TRANSPORT ASSESSMENT
VOLUME 4
RESPONSE TO HAMPSHIRE HIGHWAY AUTHORITY
PROPOSED McDONALD'S DRIVE THRU
LARCHWOOD AVENUE
HAVANT

McDonald's Restaurants Ltd
11-59 High Road
East Finchley
London
N2 8AW

ADL/AJM/2256/27A

October 2011

Figure 2A 2010 Observed Queues: Friday Pm Peak

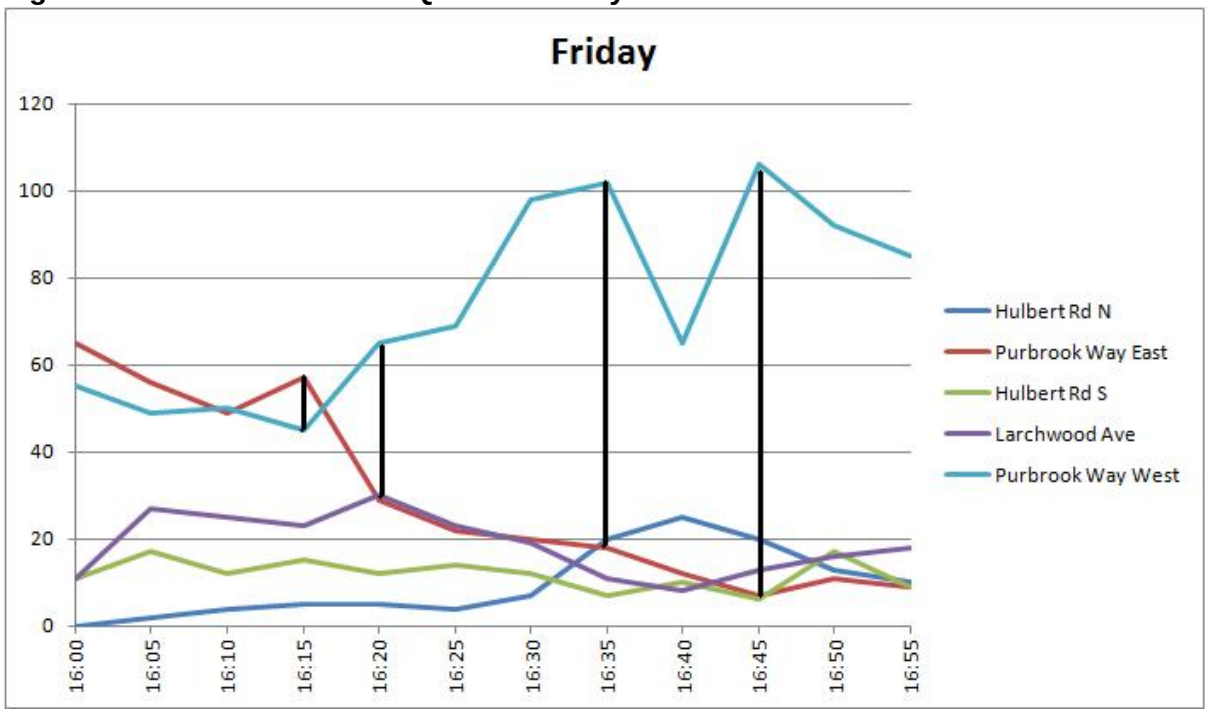
> ***"4. Section 4 of the TA provides an assessment of the current level of queuing at key local junctions. The range of observed queues reported at ASDA roundabout indicates considerable variability in network conditions. Whilst it is true in some cases that high demand on one arm is balanced by lower demand on other arms, this is not always the case. It is therefore not considered robust to use the average queue lengths as a means of calibrating model outputs against observed conditions."***

2.4.2 Figure 2A shows that on a Friday higher queuing on Purbrook Way West is balanced by lower queuing on Purbrook Way East. Similarly higher queuing on Hulbert Road North is balanced by lower queuing on Hulbert Road South.

ACCIDENT LOCATIONS (REVISED PLAN)

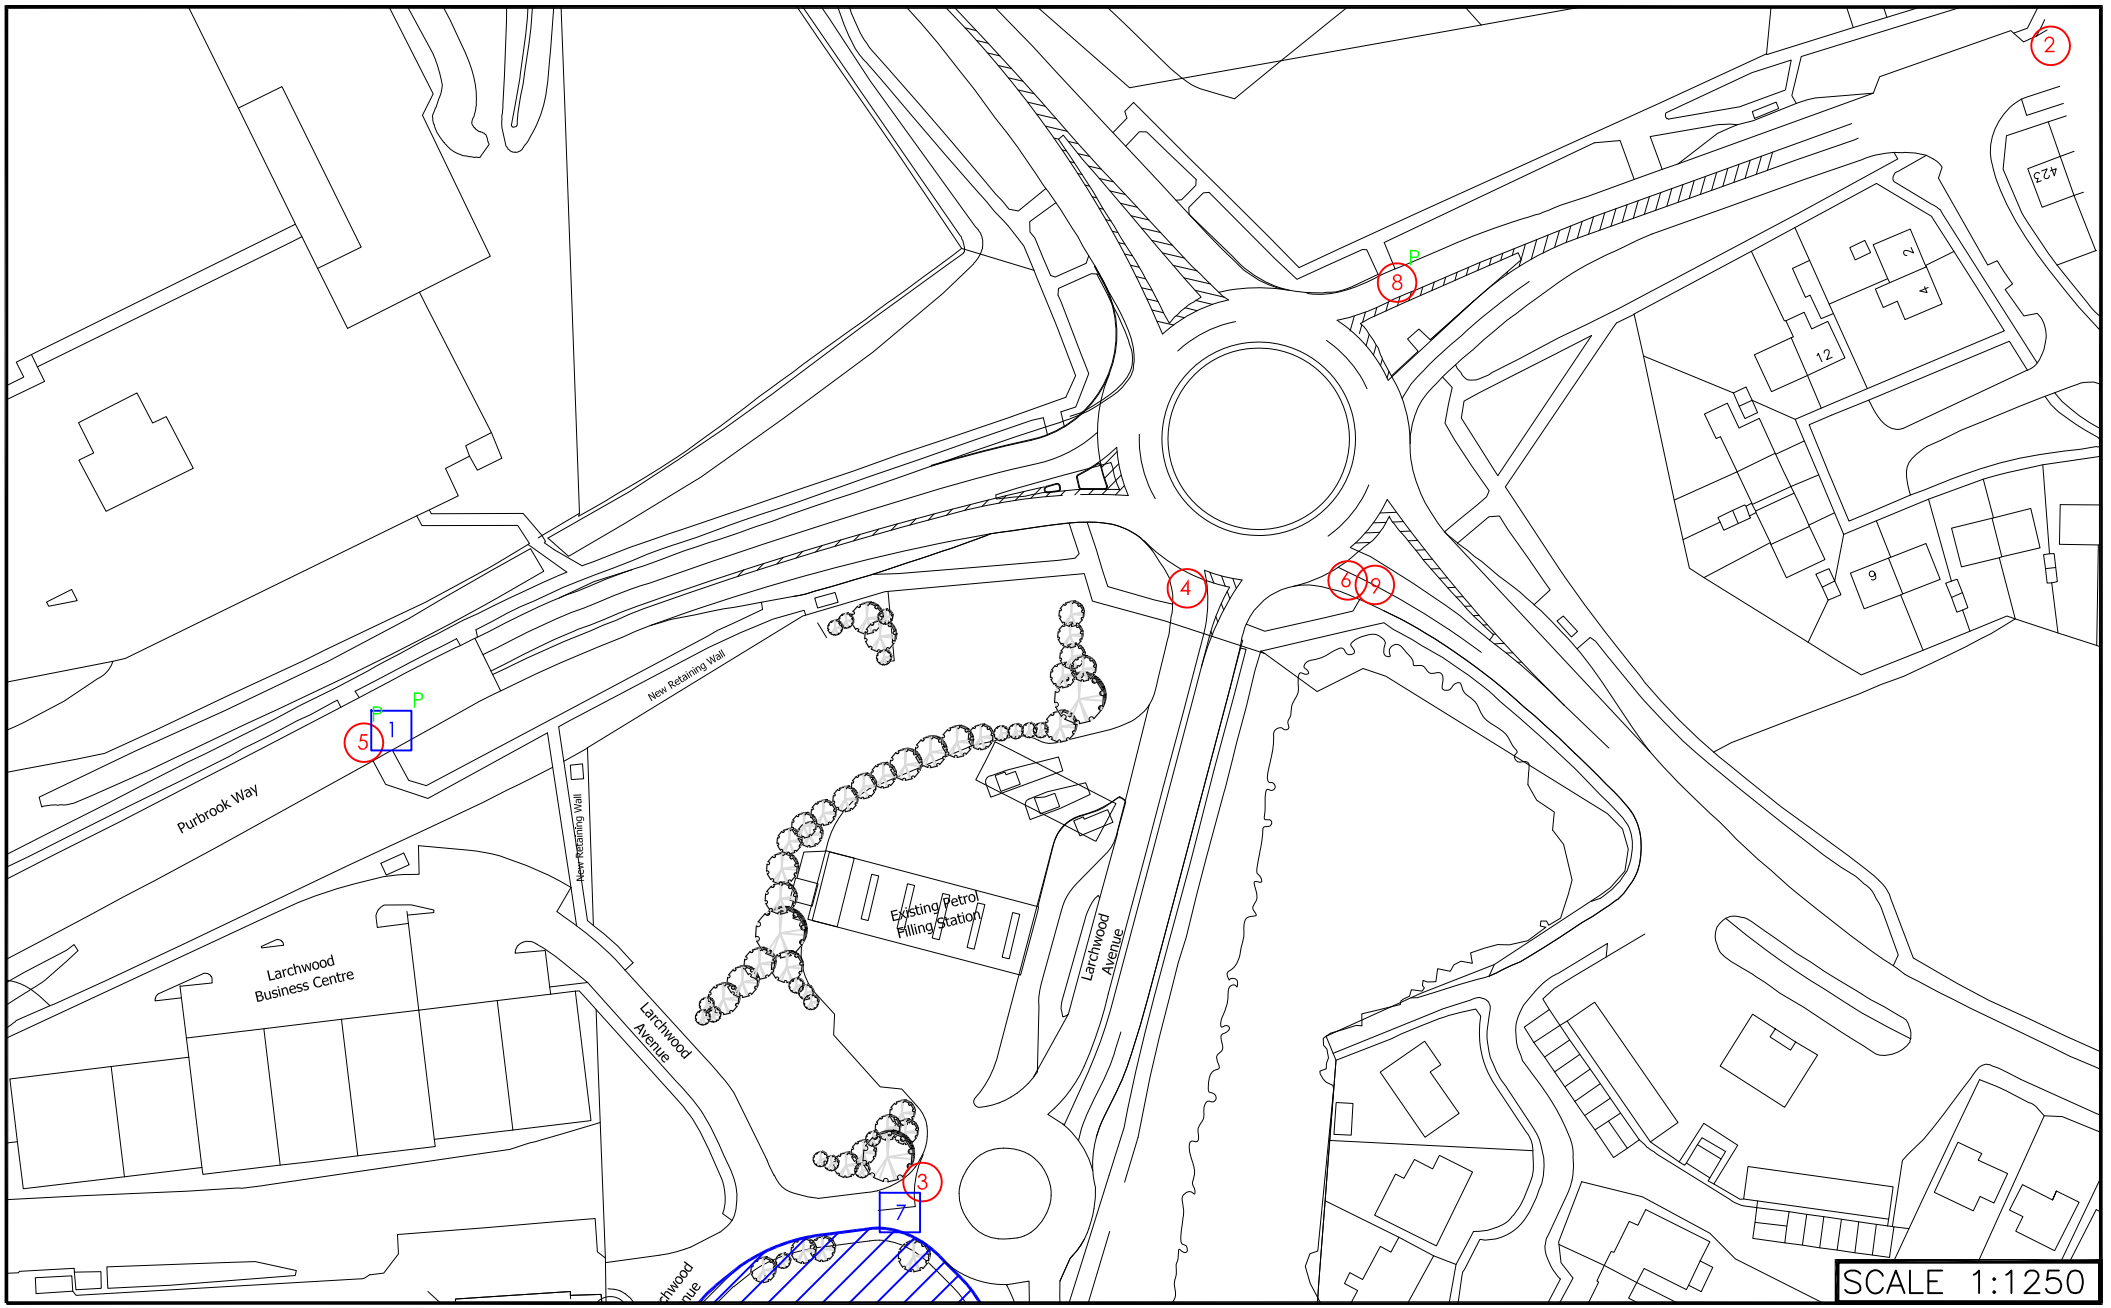
2.2.3 The accident analysis in Table 2B of ADL TA Vol 1 demonstrates that two accidents occurred on Purbrook Way West involving pedestrians (Accident №s 1 and 5). The plan in Appendix 3.0 shows the location of these accidents more clearly. Accident № 1 occurred 14/11/2007 and Accident № 5 occurred 11/10/2009.

2.2.5 The location of accident № 8 is given as Purbrook Way East. However, the description states that a car travelling east along Purbrook Way after the junction with Hulbert Road does not react to the red light at pelican crossing north along Purbrook Way.

2.2.4 In December 2009 a new toucan crossing on Purbrook Way West was installed close to where these pedestrian accidents occurred. Therefore appropriate measures have already been undertaken to address the highway safety issue in this location and increase the pedestrian and cycle accessibility.

2.2.6 There are no pelican crossing facilities on Purbrook Way East at this location. It is therefore considered that there is an error in the accident reporting. The nearest pelican crossing on Purbrook Way East is 560m from the Asda Roundabout between Linkenholt Way and the Purbrook Way/Park Lane Roundabout.
